Work Order ID 54369 -1

Item ID: D3303-041 Accept  Setup Start 
 Revision ID:
 Item Name: Head Rest Stop 
 Start Date: 08/12/2009 Start Qty: ~~40.00~~ ²⁰  Cust Item ID:
 Required Date: 16/12/2009 Req'd Qty: 40.00  Customer:
 Reference:
 Approvals: Process Plan: *RP* Date: *04-0-5* Tooling: _____ Date: _____
 QC: _____ Date: _____ SPC (Y/N): _____ Date: _____

DESIGN <i>[Signature]</i>	DRAWN BY <i>[Signature]</i>	DART AEROSPACE LTD HAWKESBURY, ONTARIO, CANADA	
CHECKED <i>PH</i>	APPROVED <i>[Signature]</i>	DRAWING NO. D3303	REV. B SHEET 1 OF 4
DATE 06.08.17		TITLE HEAD REST	SCALE 1:3
REV A	DATE 04.08.18	DESCRIPTION NEW ISSUE	
B	06.08.17	UPDATED FLAT PATTERN TO FORM PART IN ONE OPERATION USING OFFSET DIE

DRAWING NO. D3303	TITLE HEAD REST	REV. B	DART AEROSPACE LTD ENGINEERING ORDER		D.E.O. NO. D3303-B-1	SHEET NO. SHEET 1 OF 1	SCALE NTS
DRAWN AJS	CHECKED <i>h</i>	MFG. APPR. <i>h</i>	APPROVED <i>h</i>	DE APPR. <i>h</i>			
DATE 08.10.15	DATE <i>08.10.15</i>	DATE <i>08/10/16</i>	DATE <i>08/10/16</i>	DATE <i>08/10/16</i>

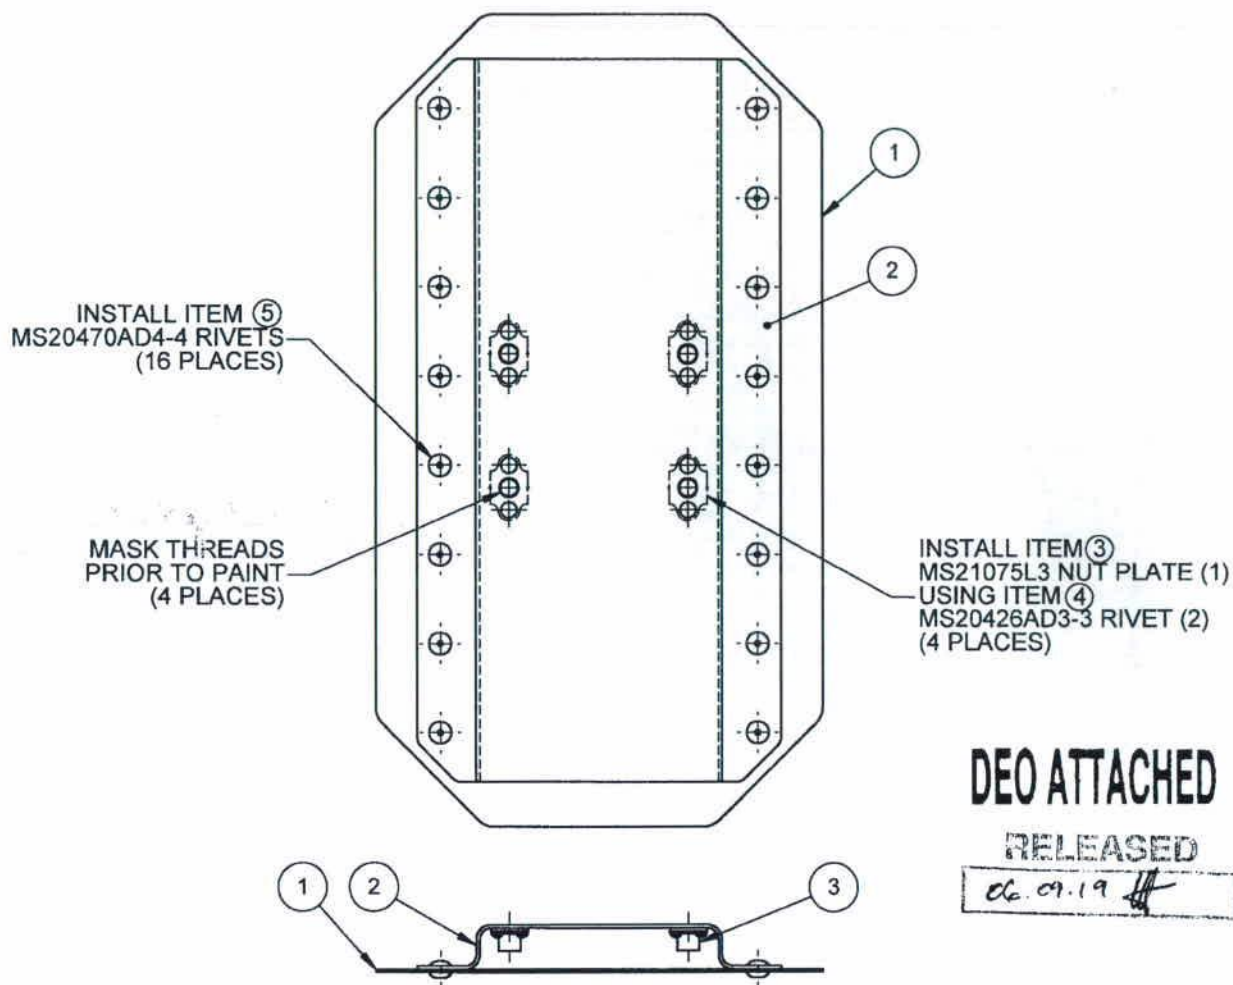
SHEET 1 ADD 1300L ADHESIVE BY 3M TO NOTE 1 AS FOLLOWS:

SEE NCR 08-069 FOR FURTHER DETAILS

IS:

- 1) BOND D3305-1 FOAM TO D3303-043 BRACKET ASSEMBLY USING 3M 1300 OR 1300L ADHESIVE (0.002" TO 0.010" THICK) IN ACCORDANCE WITH MANUFACTURER'S INSTRUCTIONS
